10.4 Other Features of Steam and Power Conversion

The information in this section of the reference ABWR DCD, including all subsections, tables, and figures is incorporated by reference with the following departures and supplements.

Figure 10.4-1 Main Condenser Evacuation System

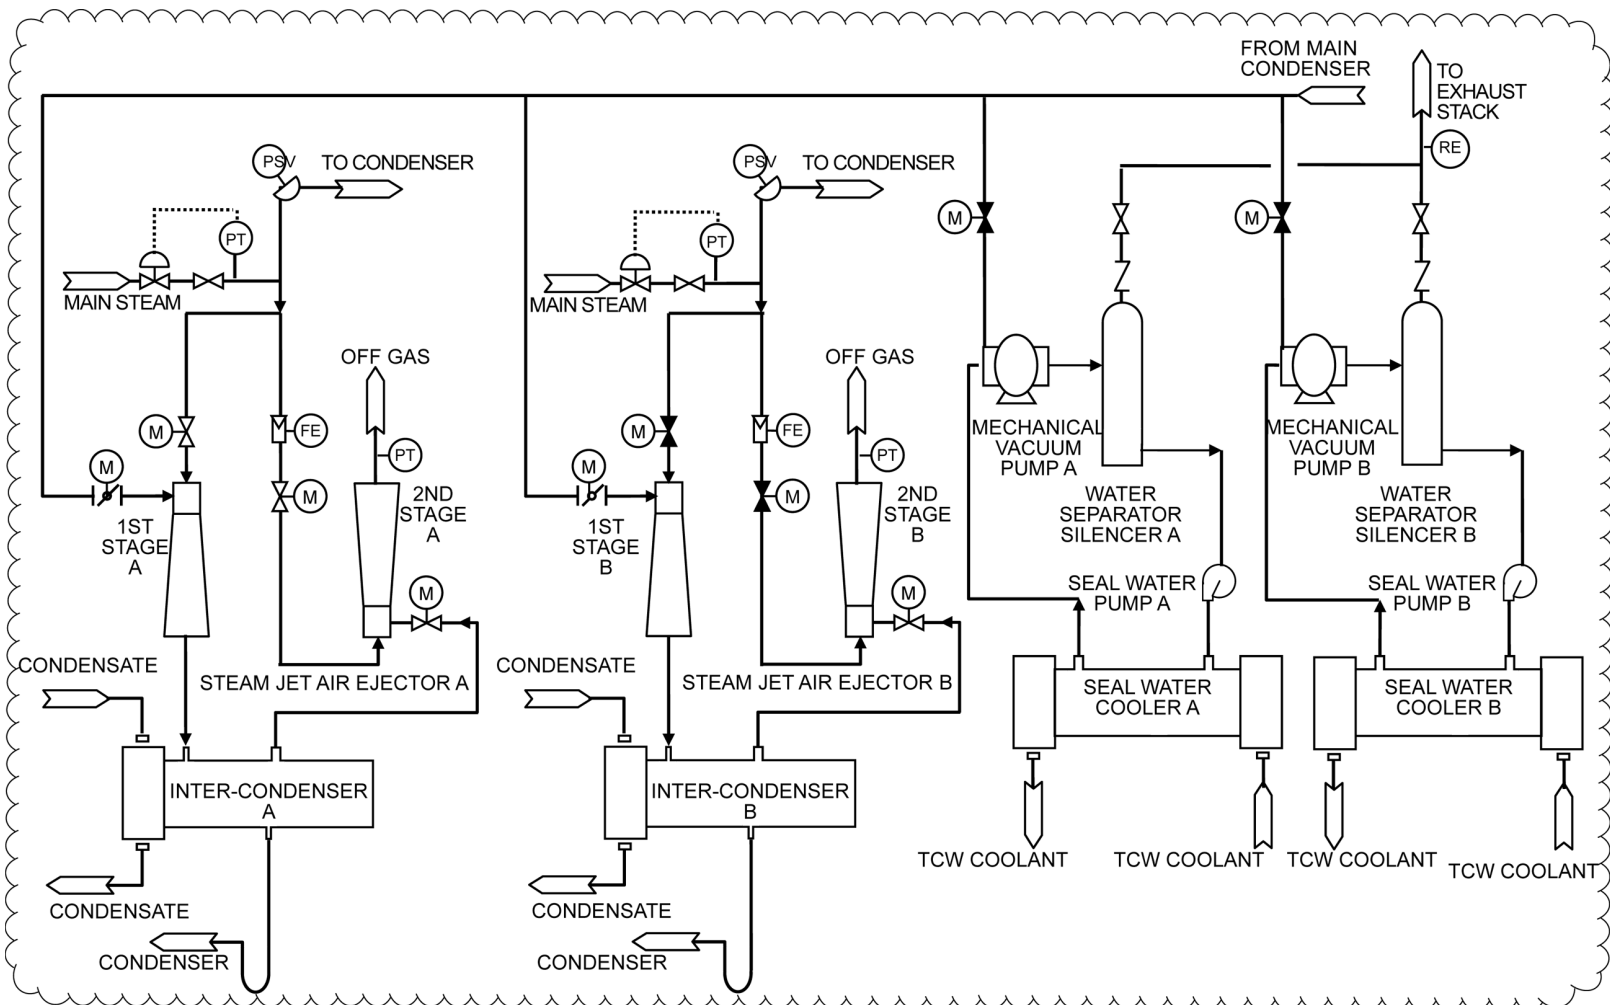
STP DEP 10.4-3 (Table 10.4-2, Figure 10.4-1)

The MCES (figure 10.4-1) consists of two 100%-capacity, double stage, steam jet air ejector (SJAE) units (complete with ~~intercondenser~~ intercondensers) for power plant operation, and ~~a two, 100% mechanical vacuum pump pumps~~ for use during startup. The last stage of the SJAE is a noncondensing stage. One SJAE unit is normally in operation and the other is on standby.

The SJAEs are placed in service to remove the gases from the main condenser after a pressure of about ~~0.034 to 0.051 MPa~~ 7kPa absolute or less is established in the main condenser by the mechanical vacuum pumps and when sufficient nuclear steam pressure is available.

Figure 10.4-2 Turbine Gland Seal System

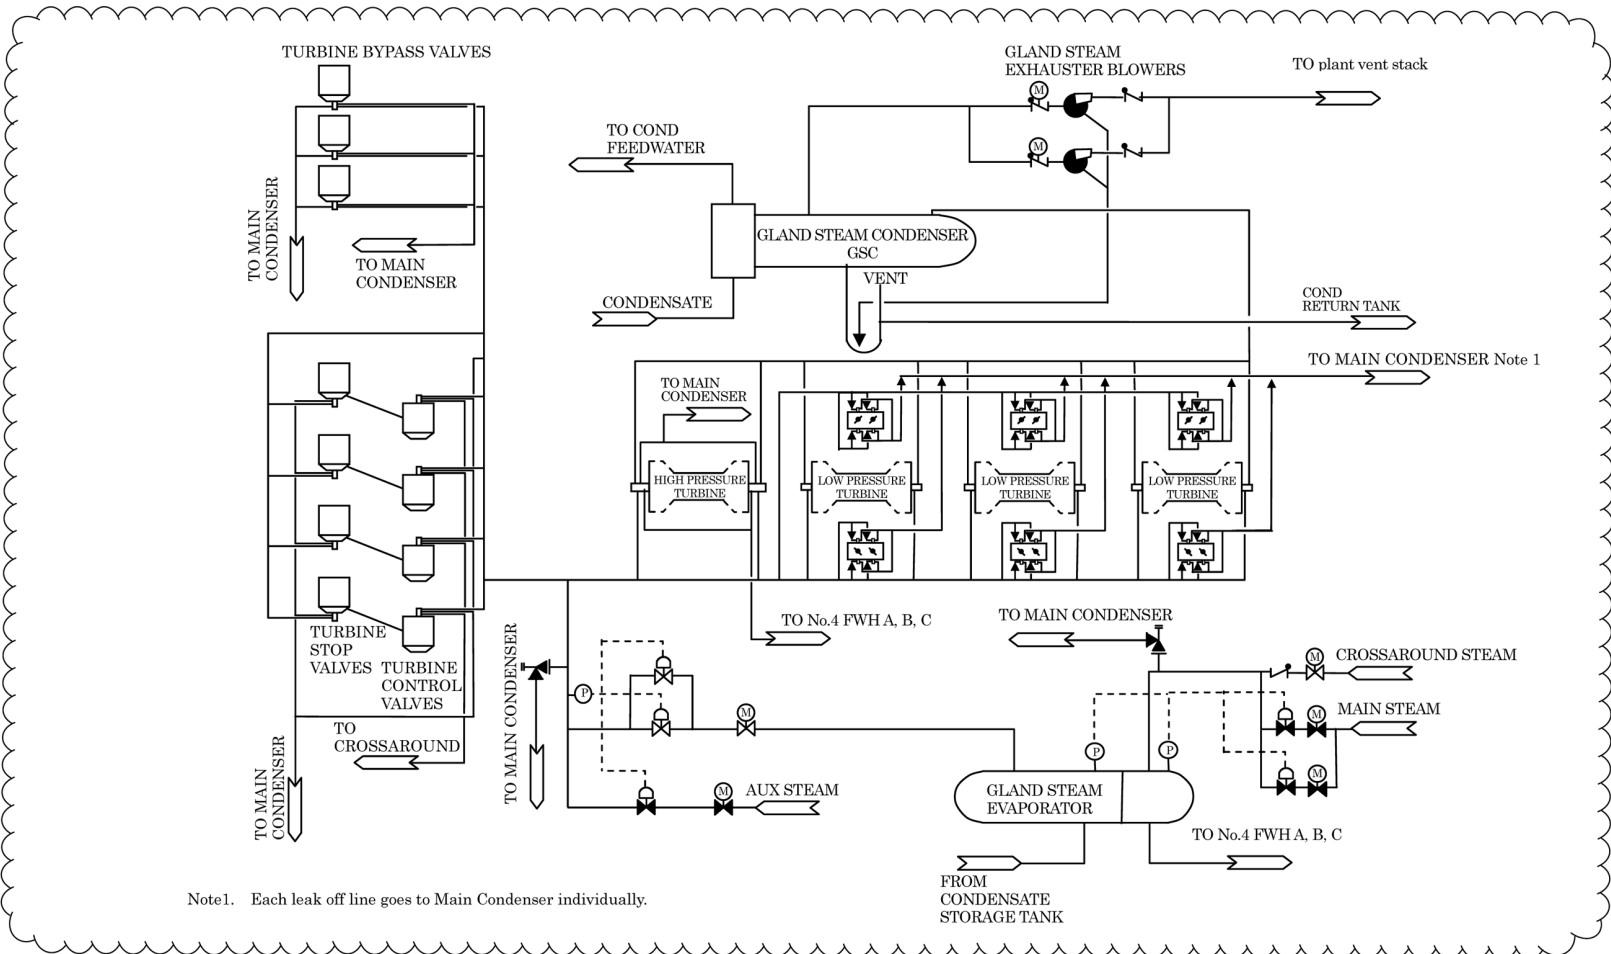
STD DEP 10.4-1 (Figure 10.4-2)

The turbine gland seal system is illustrated in Figure 10.4-2. The turbine gland seal system consists of a gland steam evaporator, sealing steam pressure regulator, sealing steam header, a gland steam condenser with two full-capacity exhausters blowers, and the associated piping, valves and instrumentation.

Figure 10.4-3 Circulating Water System

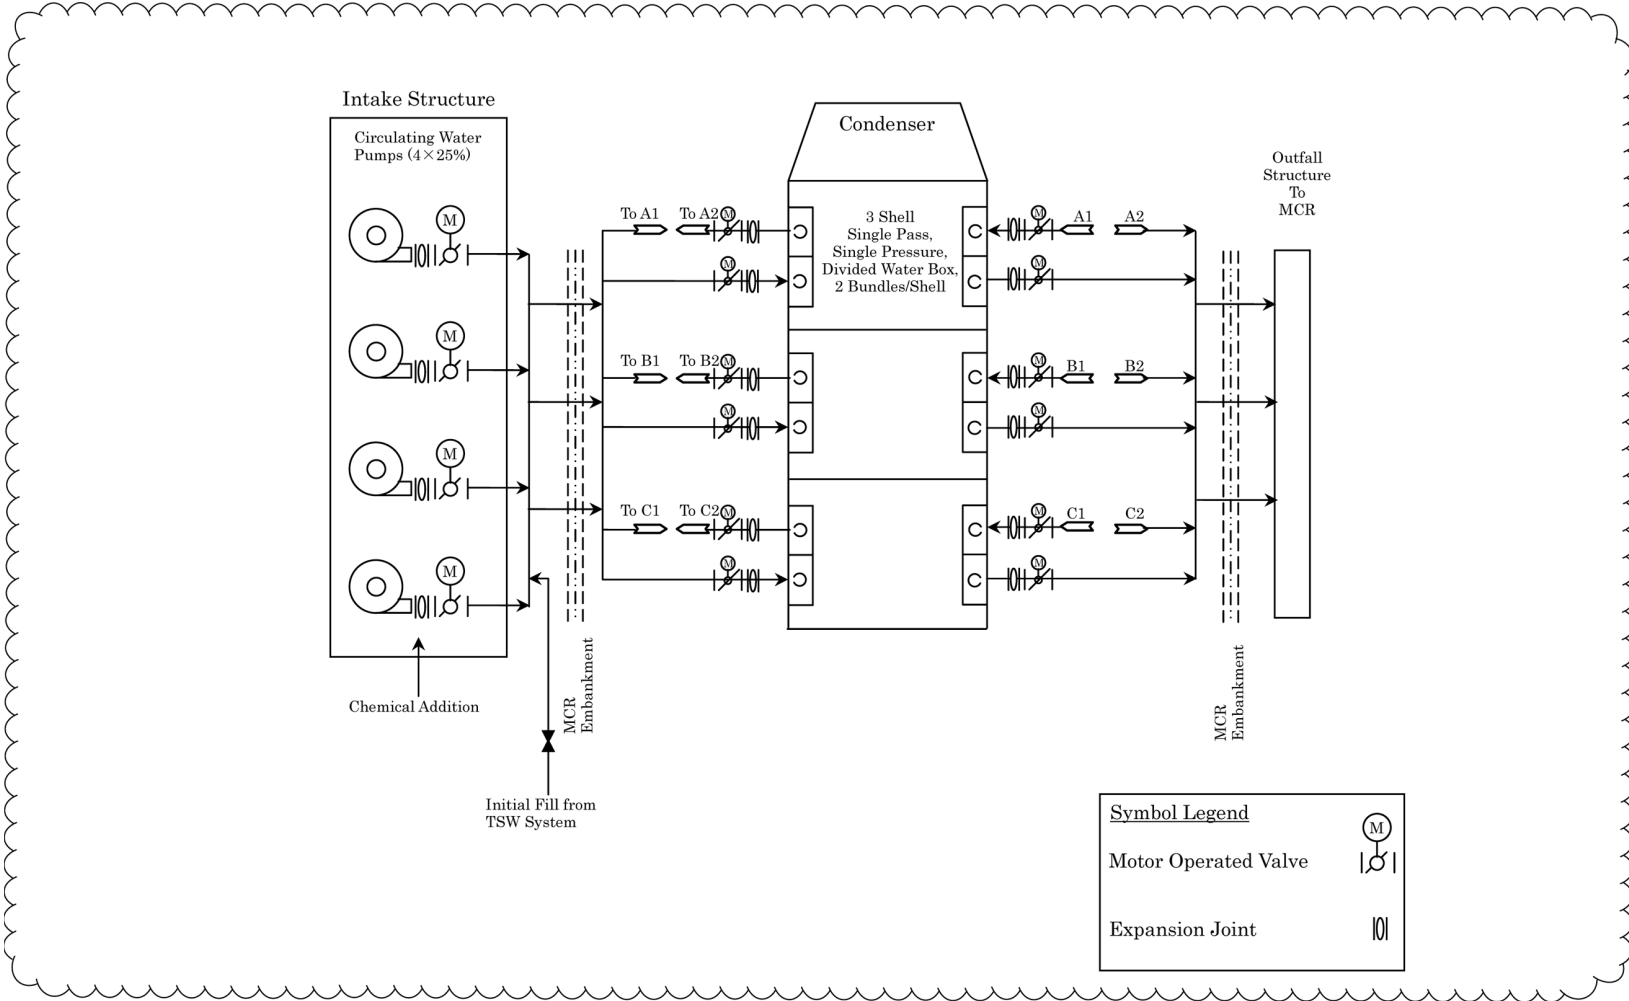
STP DEP 10.4-2 (Table 10.4-1, Table 10.4-3, Figure 10.4-3)

~~The three condenser shells are designated as the low pressure shell, the intermediate pressure shell, and the high pressure shell. The three condenser shells are cross-connected to equalize pressure. Each shell has at least two tube bundles. Circulating water flows in series parallel through the three single-pass shells (Figure 10.4-3).~~

The Circulating Water System (Figure 10.4-3) consists of the following components: (1) ~~screen house~~ intake structure and intake screens, pumps, (2) condenser water boxes and piping and valves, (3) tube side of the main condenser, (4) water box fill and drain subsystem, and (5) related support facilities such as for system water treatment, inventory blowdown and general maintenance.

Four 25% capacity fixed speed circulating water pumps per unit discharge into a common header shown in Figure 10.4-3. The discharge of each pump is fitted with a motor operated butterfly valve. The circulating water is pumped through the main condenser and back to the MCR via a discharge outfall at a nominal rate of 272,550 m³/h per unit. To provide capability for condenser waterbox isolation, isolation valves are located on the circulating water inlet and outlet lines.

Figure 10.4-5 Condensate System

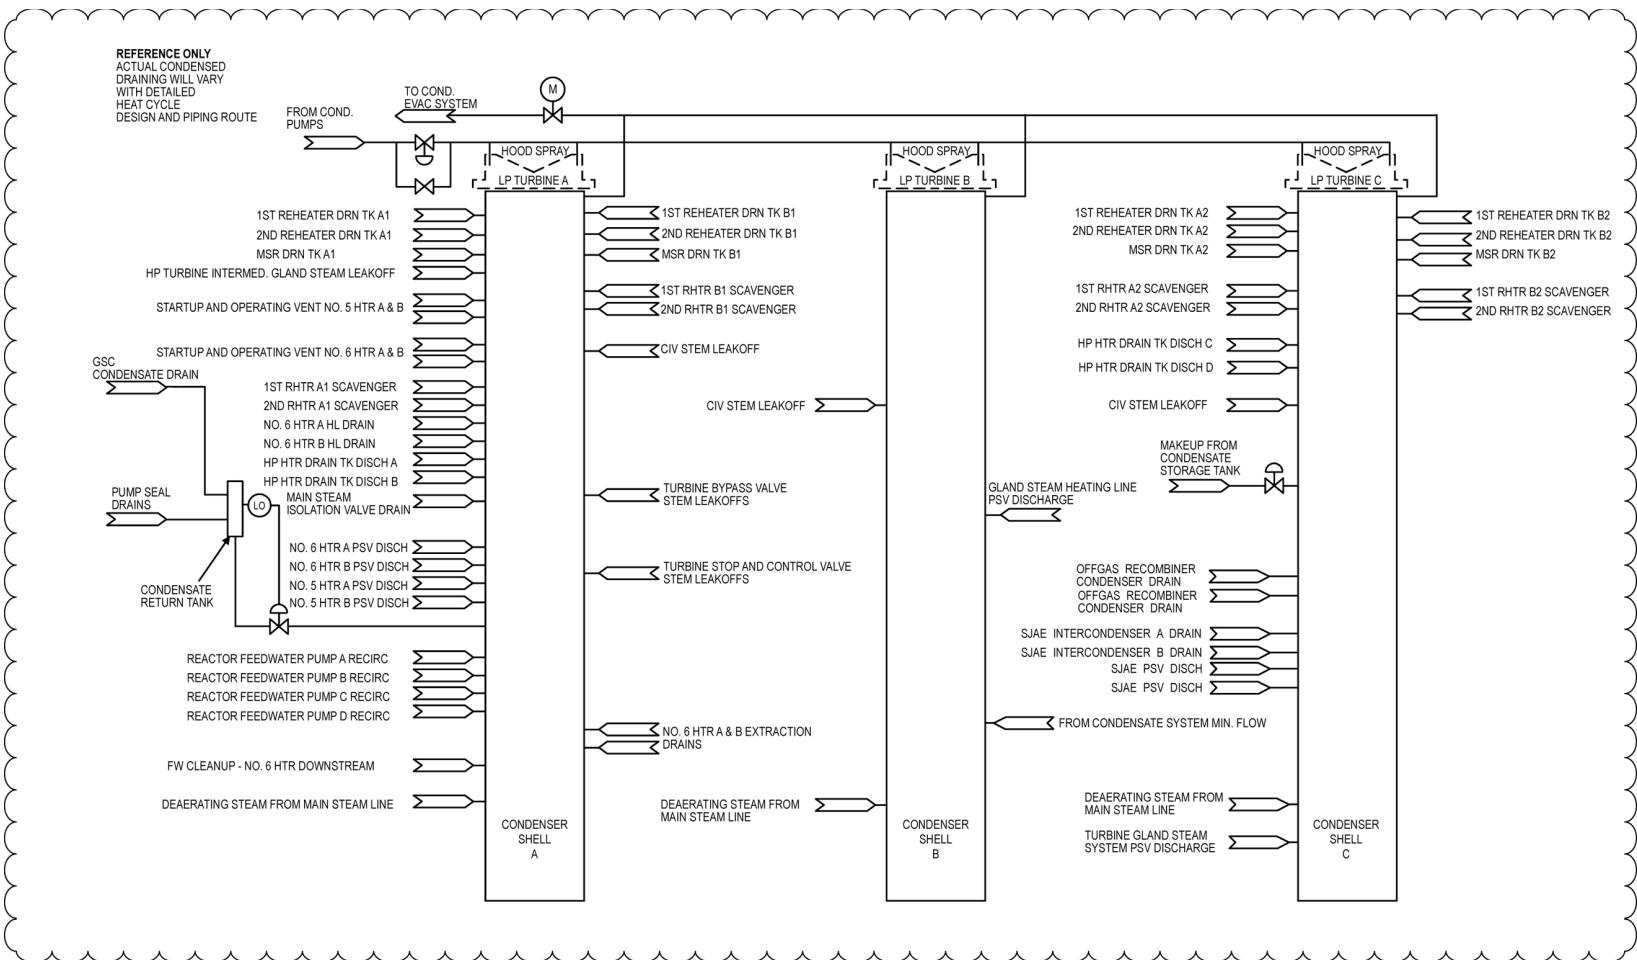
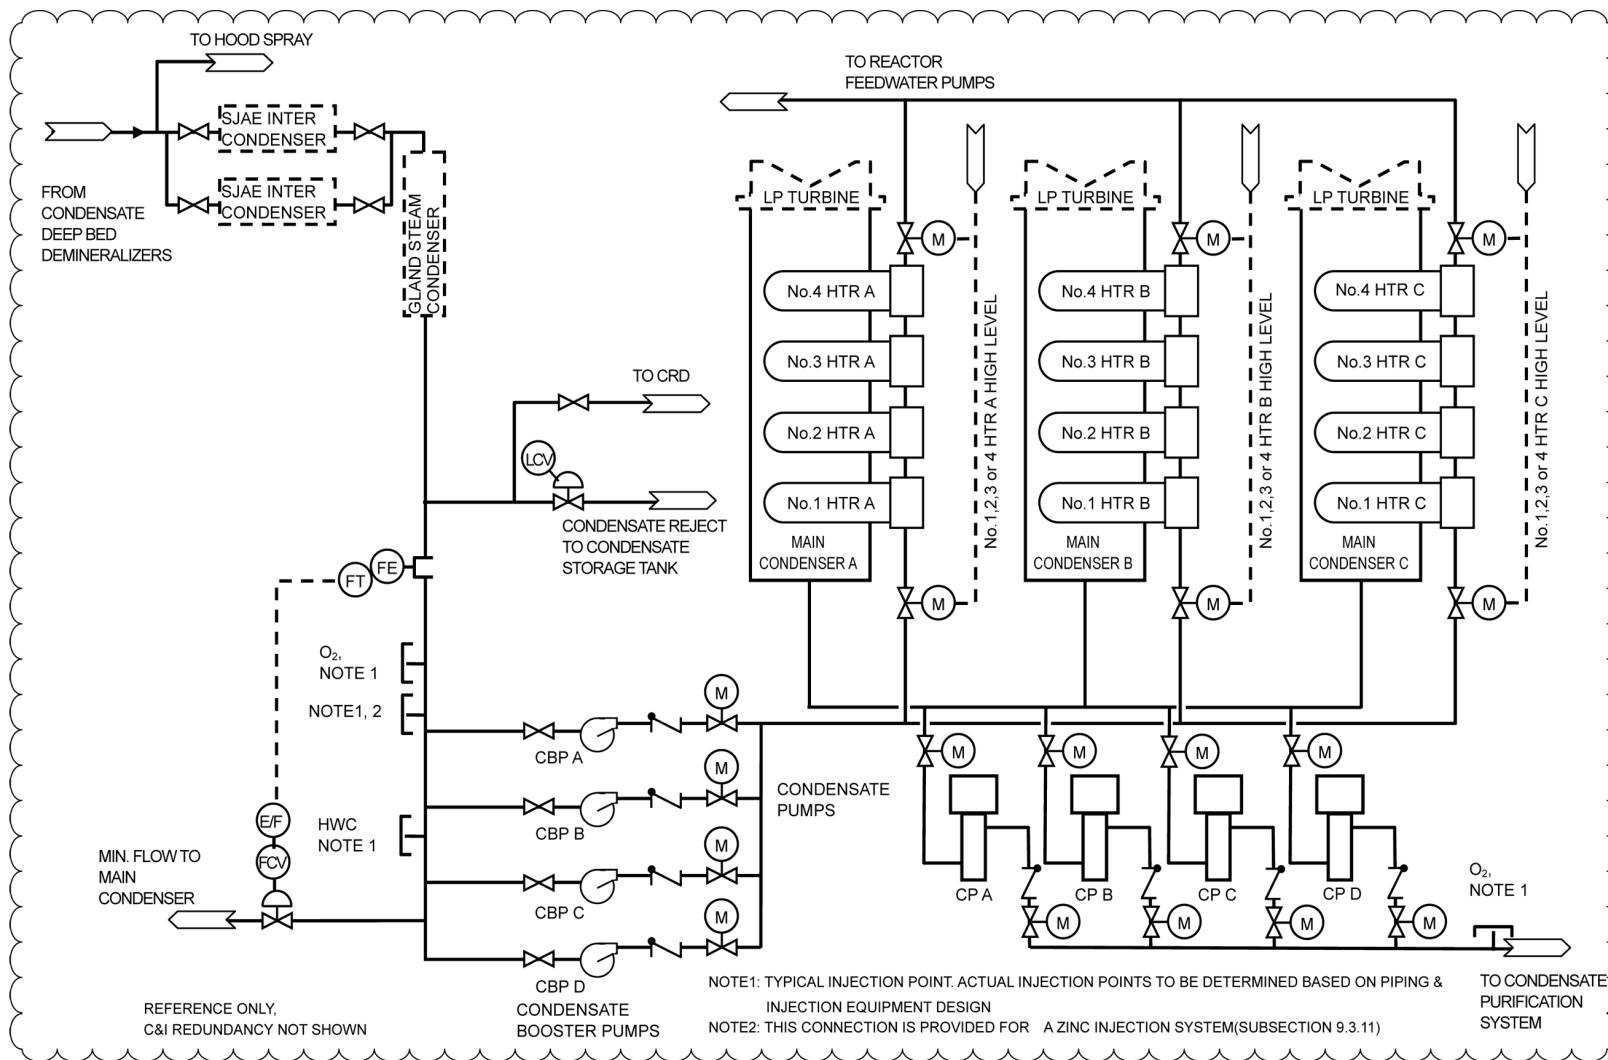
STD DEP 9.2-3 (Figure 10.4-5)

STD DEP 10.4-5 (Tables 10.4-4, 10.4-5 and 10.4-6, Figures 10.4-5, 10.4-6, 10.4-7, and 10.4-8)

The Condensate and Feedwater System (Figures 10.4-5 and 10.4-6) consists of the piping, valves, pumps, heat exchangers, controls and instrumentation, and the associated equipment and subsystems which supply the reactor with heated feedwater in a closed steam cycle utilizing regenerative feedwater heating. The system described in this subsection extends from the main condenser outlet to (but not including) the seismic interface restraint outside of containment. The remainder of the system, extending from the restraint to the reactor, is described in Chapter 5. Turbine cycle steam is utilized for a total of six stages of closed feedwater heating. The drains from each stage of the low-pressure feedwater heaters are cascaded through successively lower pressure feedwater heaters except the lowest and second lowest pressure feedwater heaters which drain to the low pressure heater drain tanks for each string. The drains from each low pressure heater drain tank flow into the external drain coolers of each lowest pressure feedwater heater and finally to the main condenser. The high pressure heater drains are pumped backward to the reactor feedwater pumps suction. The cycle extraction steam, drains and vents systems are illustrated in Figures 10.4-7 and 10.4-8.

The CFS consists of four ~~33-50%~~ 33% capacity condensate pumps (three normally operating and one on automatic standby), four 33% capacity condensate booster pumps, (three normally operating and one on automatic standby). ~~three normally operated 33-65%~~ four 33% capacity reactor feedwater pumps (three normally operating, one on automatic standby), four stages of low-pressure feedwater heaters, and two stages of high- pressure feedwater heaters, piping, valves, and instrumentation. The condensate pumps take suction from the condenser hotwell and discharge the deaerated condensate into one common header which feeds the condensate filter/demineralizers. Downstream of the condensate demineralizers, the condensate is taken by a single header and flows ~~in parallel through five~~ through the auxiliary condenser/coolers, one gland steam exhauster condenser, and two sets of SJAE condensers, ~~offgas recombiner condenser (coolers).~~ The condensate then branches into three parallel strings of low pressure feedwater heaters. Each string
